Access Compliance Report

Public Rights-of-Way

(Curb Ramps)

Intersection ID: N/A	Main Street: GROVER RD	Cross Street: N/A	Location: W
ADA ID: 78253152CA82	Ramp Type: Perp	Initial Pass/Fail: Fail	Overall Compliance: No
Codes/Mitigation Info/Possible Solution		Field Measurements/Component Compliance	
Severity Score: 13.75

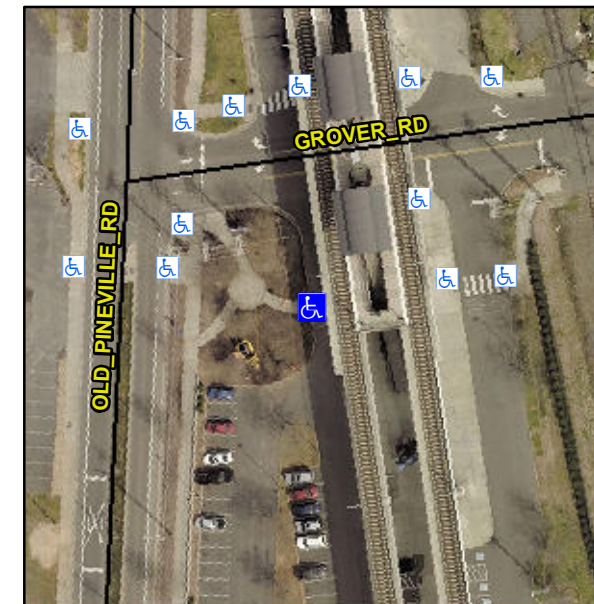
R304.2.2, R304.5.3

Compliance	Description	Data	Compliance	Description	Data
N/A	Ramp Length (in)	72.0	No	Ramp Slope (%)	9.4
Yes	Ramp Width (in)	48.0	No	Ramp XSlope (%)	2.2
N/A	Flare Type LT	N/A	N/A	Flare Type RT	N/A
N/A	Flare Slope LT (%)	N/A	N/A	Flare Slope RT (%)	N/A
N/A	Flare Traversable LT?	No	N/A	Flare Traversable RT?	No
N/A	Landing Length (in)	N/A	N/A	DWS Provided?	N/A
N/A	Landing Width (in)	N/A	N/A	DWS Contrast?	N/A
N/A	Landing Slope (%)	N/A	N/A	DWS Length (in)	N/A
N/A	Landing X Slope (%)	N/A	N/A	DWS Full Width?	N/A
N/A	Landing Curb? (Y/N)	N/A	N/A	DWS Offset (in)	N/A
N/A	Shared Landing?	N/A			
N/A	Gutter Ponding?	N/A	N/A	Gutter Slope (%)	N/A
N/A	Gutter Lip Ht (in)	N/A	N/A	Gutter X Slope (%)	N/A
N/A	Painted X Walk1?	Yes	N/A	Painted X Walk2?	N/A
	X Walk 1 Direction	To E		X Walk 2 Direction	N/A
N/A	X Walk 1 Width (in)	125.0	N/A	X Walk 2 Width (in)	N/A
	X Walk 1 Slope (%)	0.3		X Walk 2 Slope (%)	N/A
	X Walk 1 X Slope (%)	0.2		X Walk 2 X Slope (%)	N/A

Remove & Replace Entire Ramp.
